RE: OBJECTION TO SSD-77825469

Thank you for the opportunity to comment on State Significant Development Application (SSD-77825469) for demolition of existing buildings and construction of a residential apartment development with 178 apartments, including 39 affordable housing apartments, above basement car parking, tree removal and lot consolidation. At No. 2 – 16 Pockley Avenue, Roseville.

Ku-ring-gai Council's objection to SSD-77825469 at No. 2 – 16 Pockley Avenue, Roseville.

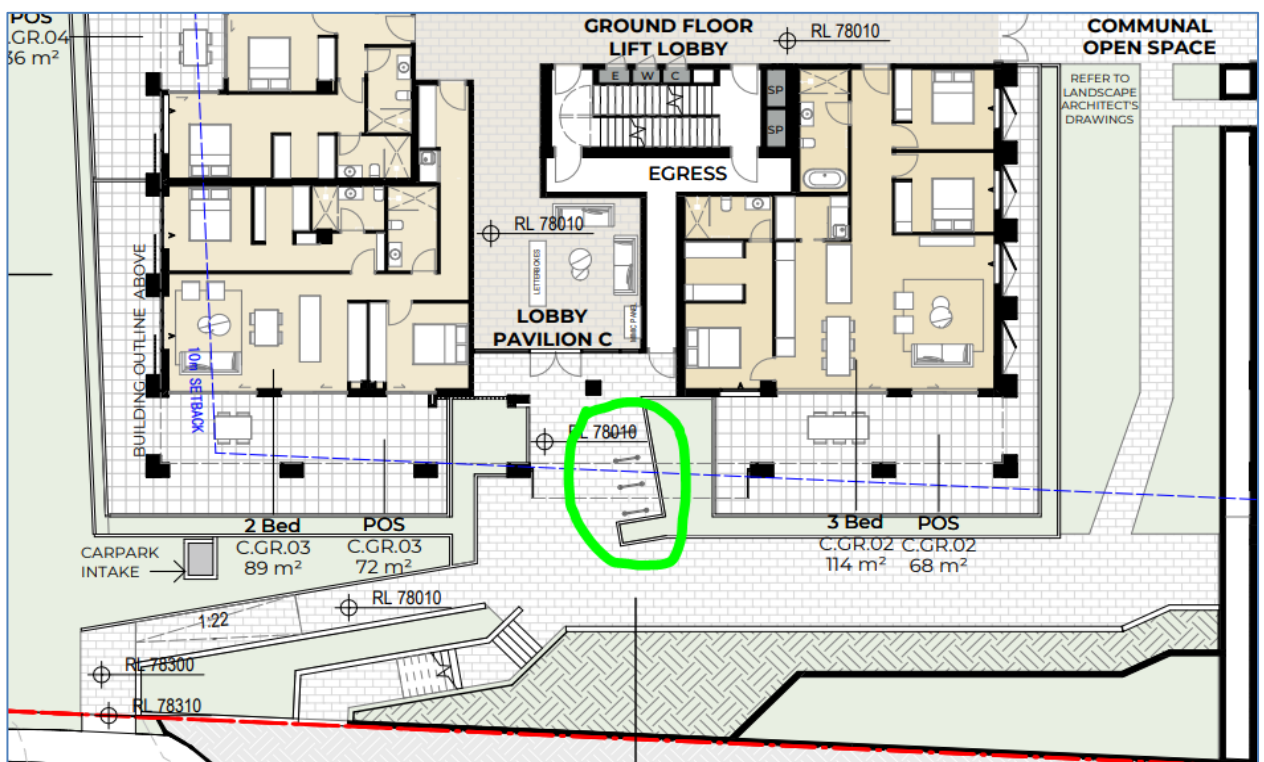
Given the site's proximity to transport, shops and amenities, the proposed parking should be reduced and supplemented with car share vehicle/s to provide access to additional travel options and reduce reliance on on-street parking. Conditions similar to the following could be imposed:

- At least 5 car parking spaces on Basement 03 level are to be reserved for car share operation, with no charge to the car share operator to use the space/s.

- The spaces must be available/accessible to verified members of the car share scheme (including members who are not residents of the development) and should be well-lit with safe pedestrian access.

- These spaces must be contracted to an operator (a Car Share Provider that has been approved by the Responsible Authority) with evidence of agreement submitted to Council prior to issuing of the Occupation Certificate.

- Car share vehicles must be operational within 4 weeks of issue of the Occupation Certificate
- The agreement must ensure appropriate insurance and vehicle maintenance is in place, including public liability.

- Since car share spaces are located in the basement, sufficient cellular communications connectivity must be available at the location of the carshare spaces to ensure proper car share management/operation.

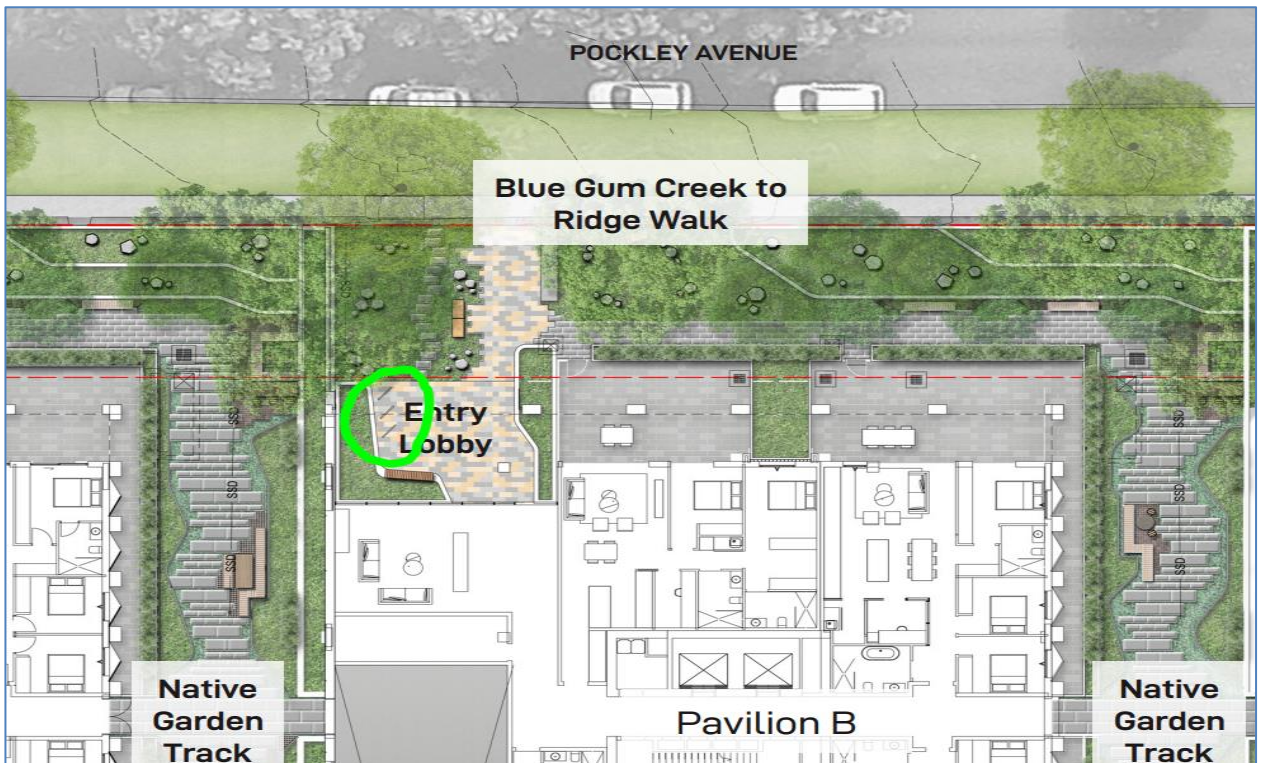
From the Architectural Plan, 4 visitor bicycle parking racks were found to be located outside the Pavilion C Lobby, which are supported:

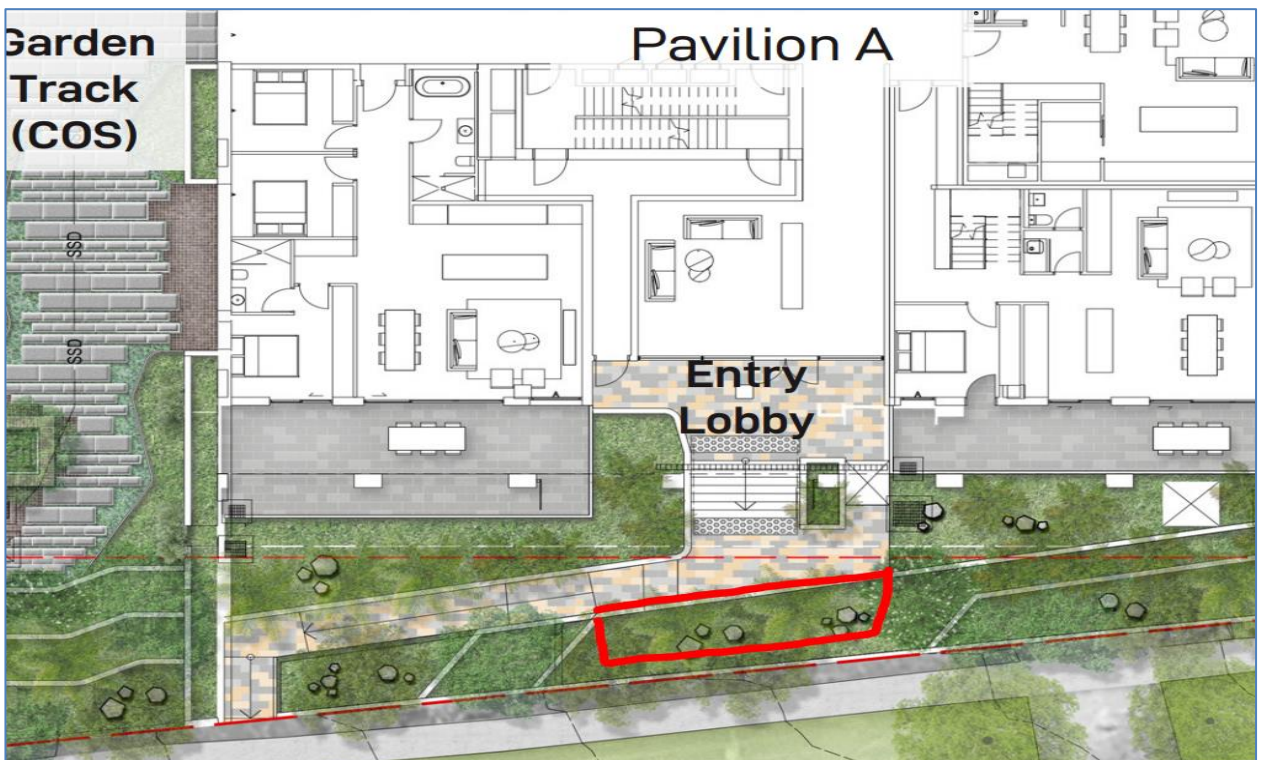
The Landscape Plan shows 3 visitor bicycle racks outside the Pavilion B Lobby, which are acceptable:

However, none could be found near the Pavilion A Lobby. It is recommended that some of the visitor bicycle racks from Pavilion B and C be re-distributed to the Pavilion A Lobby as shown in red in the Landscape Plan below: This should be included as a condition of consent.

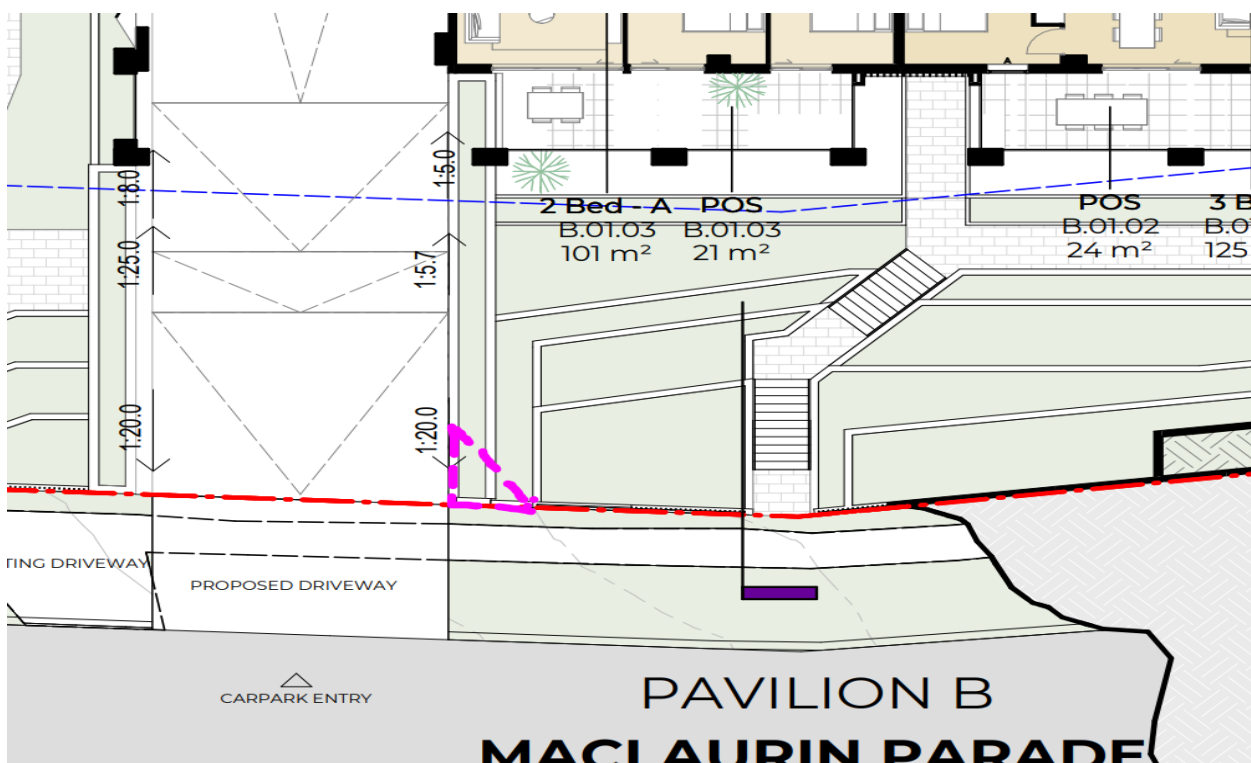
A 7.2m wide access point at the property boundary and kerb line is proposed, which is acceptable. It is unclear what the treatment is in the area of the 2m x 2.5m sight triangle as required by AS2890.1 (shown in pink below), and this needs to be clarified:

Currently, No Parking restrictions are currently in place on the MacLaurin Parade frontage of the site, from Pockley Avenue to (approximately) the western side of the proposed access point. In accordance with section P of Council's Traffic and Transport Policy, 'No Parking' restrictions for 6 metres on either side of the driveway are to be implemented prior to occupation. Council's fees and charges for referral to the Ku-ring-gai Traffic Committee and installation of signs apply.

1. Demonstrate compliance with the 2m x 2.5m sight triangle at the access point as required by AS2890.1:2004.
2. References to existing car share vehicles should be removed from Section 3.2 (Car Share) of the Green Travel Plan, as well as from the Transport Access Guide in Appendix A.
3. The commentary in Section 3.5 of the Green Travel Plan (Bicycle Routes) should be clarified with respect to the existing cycleways and useful unmarked bicycle routes referred to in Figure 3.3.

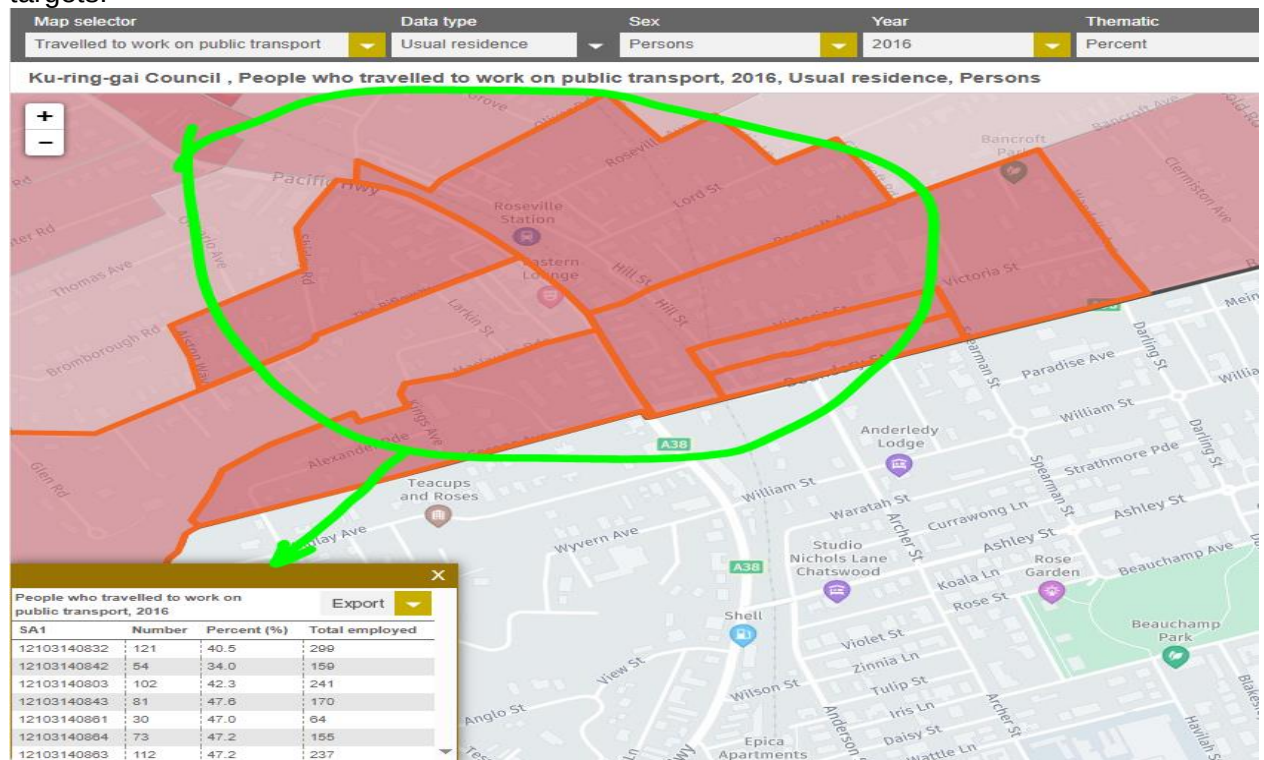
2021 Census data was used to obtain mode of travel to work for residents in the Lindfield – Roseville SA2 area, and notes that Covid travel restrictions heavily affected this data. Also, the Lindfield – Roseville SA2 area is quite extensive and would not accurately the reflect travel modes of residents living within 400m of Roseville station. It is recommended that this whole section and Section 4.2 (Mode Share Targets) be revised to use 2016 Census data and using a finer-grained SA1 analysis (available from atlas.id on Council's website ([Social atlas | Ku-ring-gai Council area | atlas.id](#))) to obtain the base travel mode data from which to set the mode share targets:

4. Section 3.6 (Existing Transport Mode Split) and Section 4.2 (Mode Share Targets) from the Green Travel Plan are to be revised using 2016 Census data and using a finer-grained SA1 analysis to obtain the base travel mode data from which to set the mode share targets.
